SUBJECT: ST. LUCIE UNIT 2 - ISSUANCE OF AMENDMENT (TAC NO. 69864)

AMENDMENT NO. 42 TO FACILITY OPERATING LICENSE NO. NPF-16 - ST. LUCIE, UNIT 2

SAFETY EVALUATION BY THE OFFICE OF NUCLEAR REACTOR REGULATION

FIGURE 2.2-2

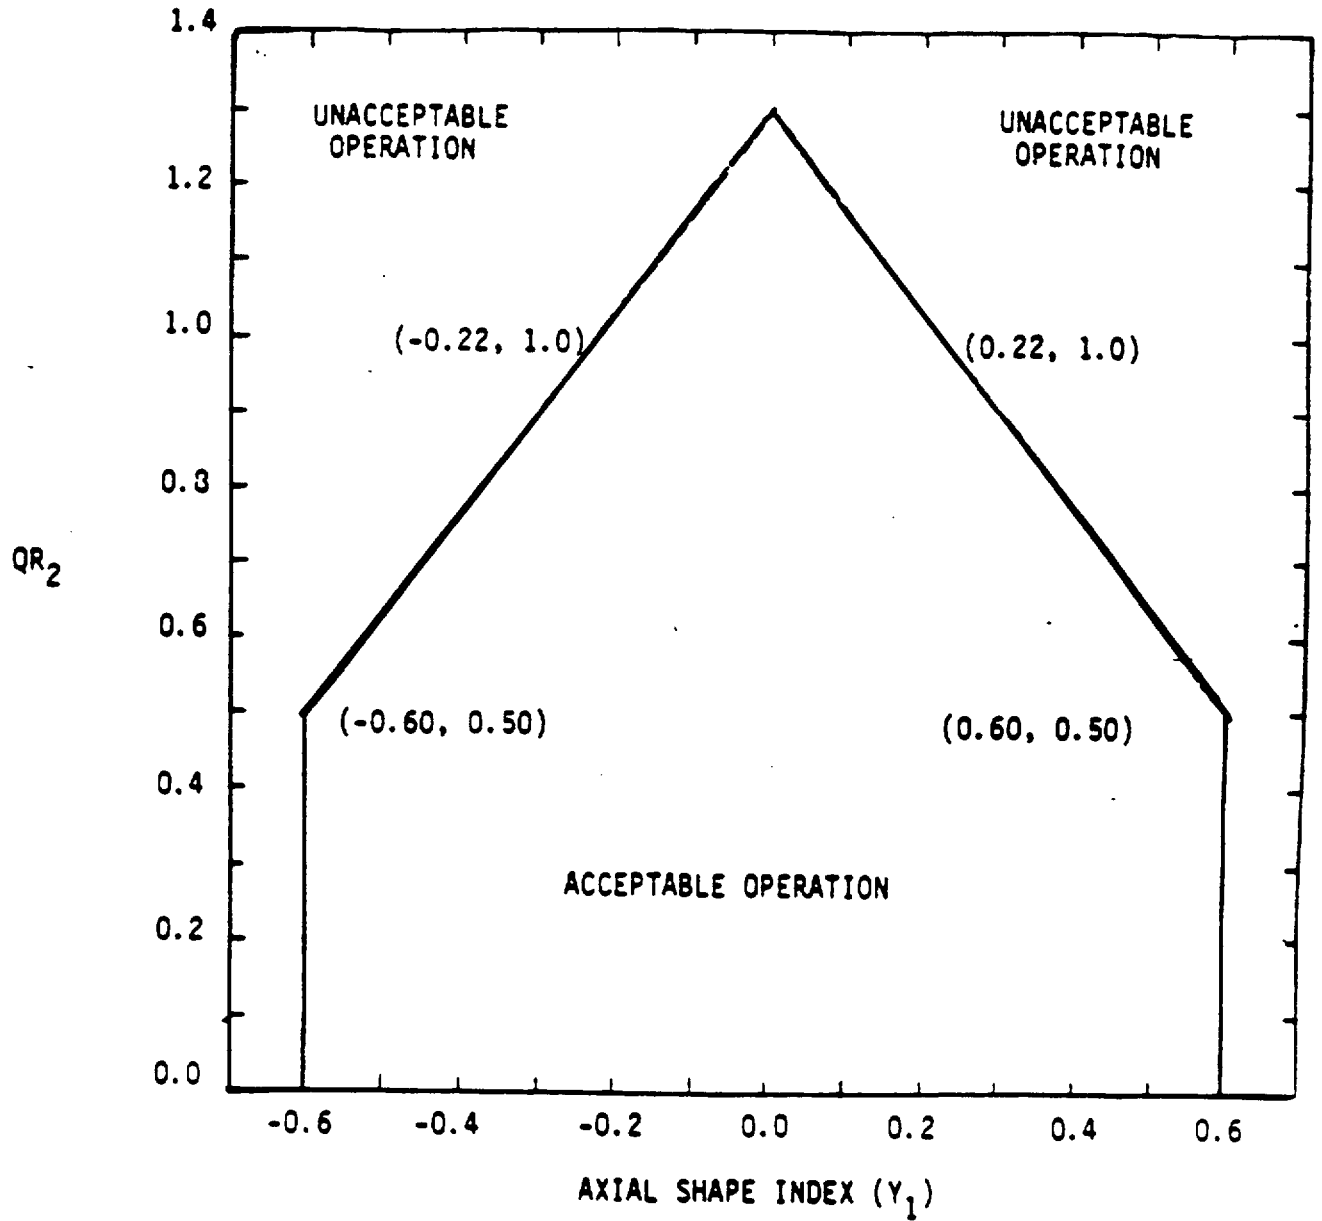
FPL proposed expansion of the LPD LSSS ASI limits for power levels below 50% from ± 0.4 to ± 0.6 , expansion of the ASI limits of the LHR LCO for powers below 60% (but above 40%) and expansion of the ASI limits of the DNB LCO for powers below 65% (but above 40%) from ± 0.3 to ± 0.5 . For Figure 2.2-2, it is also proposed to increase the ASI limits slightly above 0.8 of rated power and to raise the apex of the curve from 1.2 to 1.3.

To justify the LPD LSSS limit (Figure 2.2-2) change, FPL did an analysis which showed that the closest approach to the actual calculated LSSS limits occurs at 66% power at an ASI of +.48, with 12% margin. This margin is acceptable for operation and is consistent with the safety analysis of record.

FIGURE 3.2-2

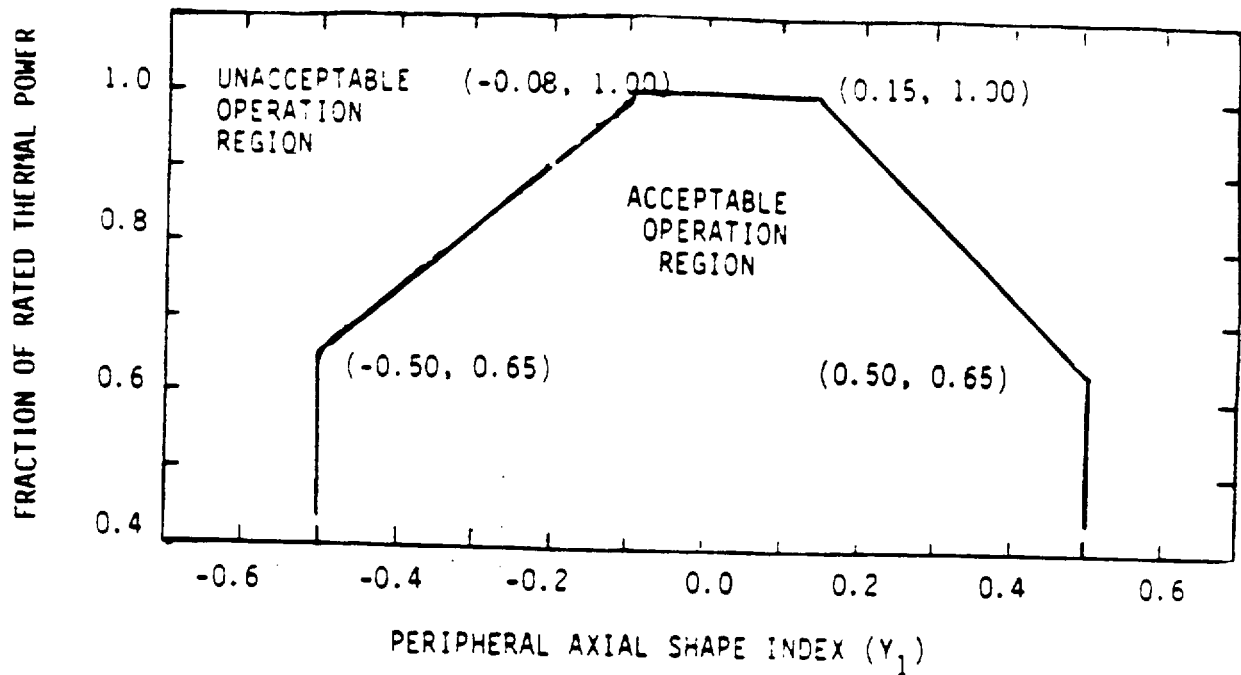
By letter dated October 24, 1988 Florida Power and Light (FPL) requested a change to the St. Lucie Unit 2 Technical Specifications on Local Power Density High Trip Setpoint. In order to achieve greater operational flexibility at lower powers FPL requested expansion of the Departure from Nucleate Boiling (DNB) and Linear Heat Rate (LHR) related Axial Shape Index (ASI) limits and LHR-related Limiting Safety System Setpoints (LSSSs). The proposed changes modify the Technical Specifications concerning the Local Power Density (LPD) LSSS (Figure 2.2-2), maximum allowed power level versus peripheral ASI for the excore detector monitoring system (Figure 3.2-2) and the DNB Limiting Conditions for Operation (LCO) fraction of rated thermal power versus peripheral ASI for four reactor coolant pump operation (Figure 3.2-4).
